NS9360

Errata

90000677-88_F

Release date: March 2008

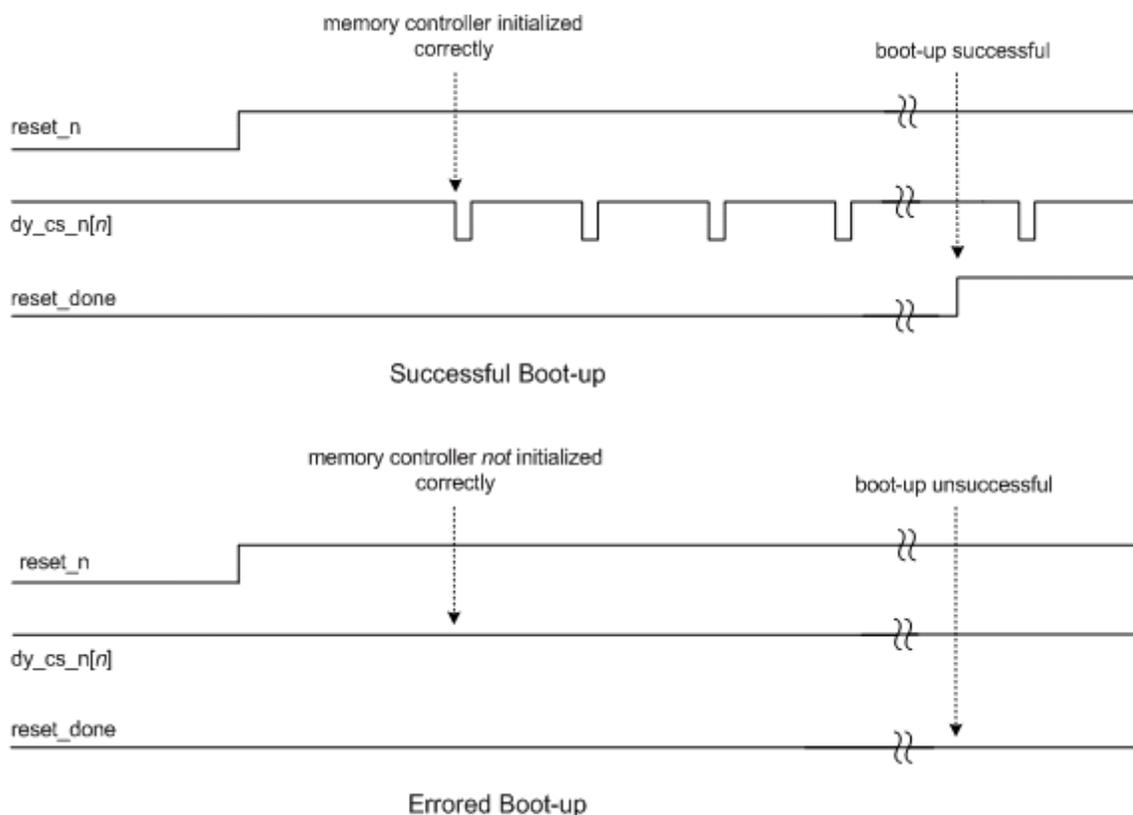
SPI boot fails intermittently - updated

SPI boot fails intermittently during power-on because of an initialization error. As a result, a manual reset to the NS9360 can sometimes be required after the initial power-up reset. SPI boot works reliably from push button reset.

A failure can also occur if the software changes the system endian bit after boot-up (bit 3 in the Miscellaneous System Configuration register). This bit is set according to the bootstrap condition on gpio[44].

The next diagrams show the timing for a proper boot-up and for an errored boot-up sequence:

Hardware workaround:

A board hardware work around can detect and recover from the error.

The board hardware workaround circuit that detects the unsuccessful boot-up is shown next. Digi recommends that you use a spare dynamic memory chip select in the workaround circuit.

If the endian bit is never changed (bit 3 in the Miscellaneous System Configuration register), the circuit fed by reset_done (inverter, flip-flop and AND gate) can be omitted. If the err_detect_n flip-flop has a Schmitt trigger clock input the Schmitt trigger buffer can also be omitted.

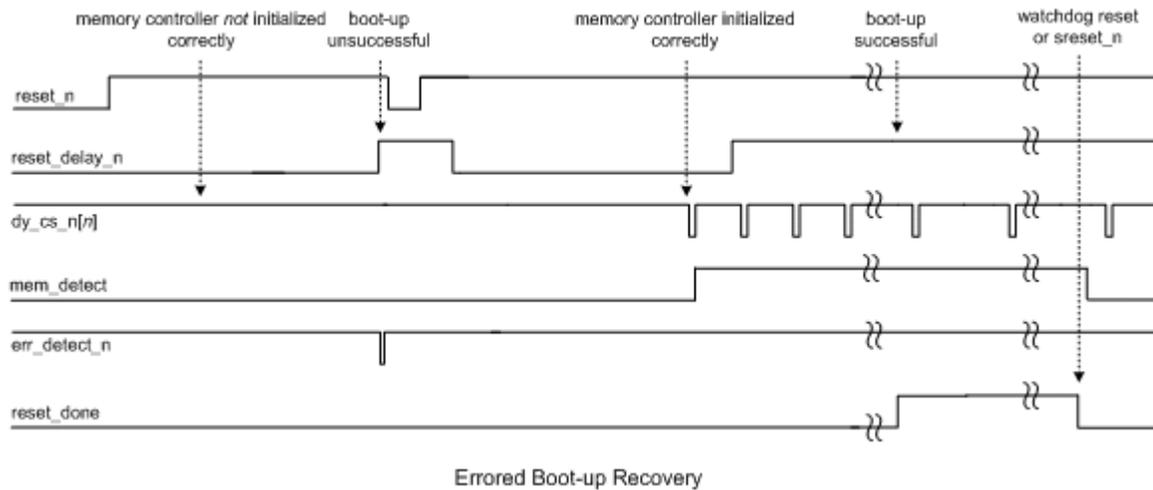
This timing diagram illustrates the recovery process:

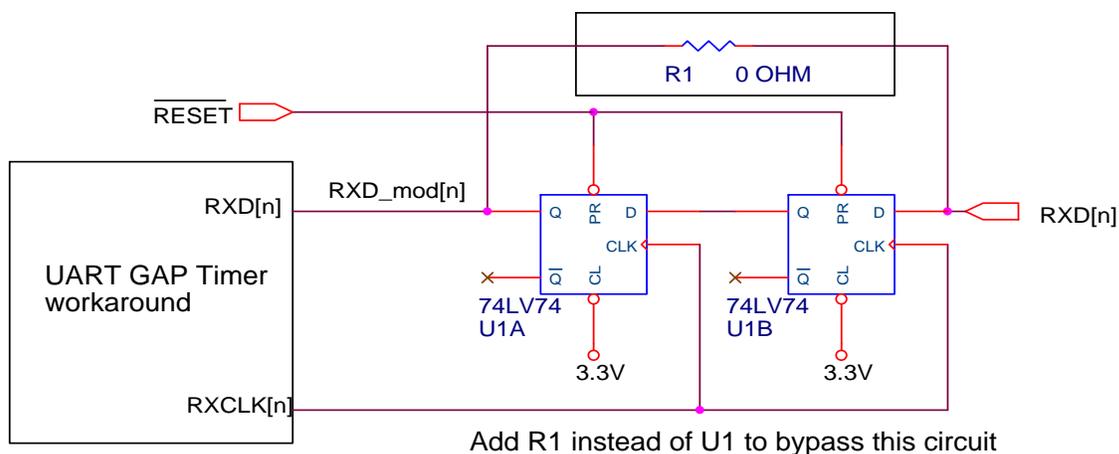
UART gap timer

The start bit of a new character may not be detected when the character or buffer gap timer expires. Framing, parity, or data corruption occur when a start bit is missed.

Hardware workaround:

Note: The hardware workaround requires that you have installed the appropriate software patch found in the NETOS SW Toolkit (on the Web).

A hardware workaround eliminates the possibility of receiving a start bit when a character or buffer gap timer is expiring. The workaround drives the baud clock off-chip and synchronizes the incoming data with this clock. As a result, the buffer and character gap timers and the next start bit have a fixed and known relationship with each other.

- The TMODE bit in the Bit-rate register must be cleared.
- Baud rates are limited to those available in x16 mode
- Baud rates with a divisor of 0 are not possible for all CPU frequencies. This translates to a maximum baud rate of 460k in x16 mode.

- Baud rates with a divisor of 1 are not possible for CPU frequencies below 147MHz. This translates to a baud rate of 230k in x16 mode.
- The buffer and character gaps must be an even multiple of the sample clock period. For a 96000bps UART in x16 UART mode, the equation is:

- $\text{Timer increment} = ((1/9600) / 16) \times 2 = 13.020\mu\text{s}$
- One GPIO per UART is required to output the baud clock. The baud clock can be output on the RI pin on each UART. This function is controlled by the RXEXT bit (27) in each Serial Bit-rate register.

- If multiple UARTs are running at the same baud rate, one baud clock can be used for the multiple UARTs.
